FIRST ALERT

Subject: Automated Siemens 8DJH RMU

Date: 14/07/2021

Figure 1: Automated 8DJH R switch

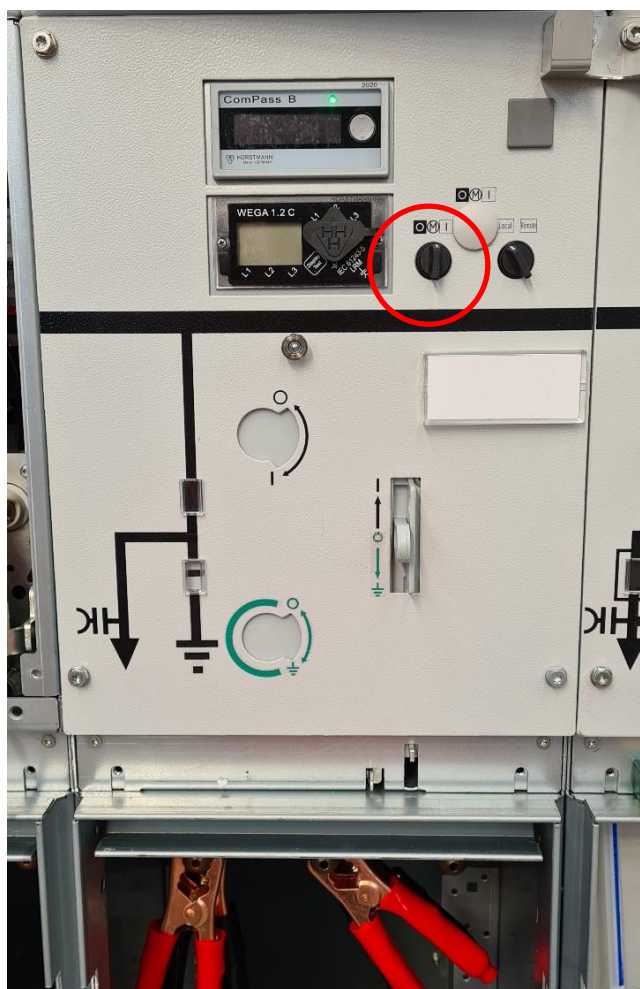
The automated Siemens 8DJH load break (R) switches do not have a lock out for the electronic open/close switch (circled in red). This allows the load break switch to be opened and closed even when manual operation has been locked and tagged. This allows the potential for inadvertently closing onto a cable that is under a test permit.

Note this is only an issue under a test permit scenario when the earth switch is open and the cable compartment door remains fitted. If the earth switch is closed or the cable compartment door is open, the switch is interlocked and can't be operated by the electronic open/close switch.

As an interim solution, these automated RMUs load break switches (R) can only be used for isolation under an access permit with the earth applied. Caution Notes have been placed against the three affected units in the NMS/SCADA system.

If testing requires the earth to be removed (e.g. test permit) then these devices cannot be used as the isolation point without the approval of the GM Asset Management or GM WEL Services.

- All new automated 8DJH RMUs are to be supplied without an electronic open/close switch.
- The existing three automated 8DJH RMUs in the network will have the electronic open/close switch removed and replaced with a blanking plate in accordance with Supplier's instruction.
- All automated RMUs still in WEL's or Service Provider's depot shall have the electronic open/close switch removed as part of the pre-installation depot testing.
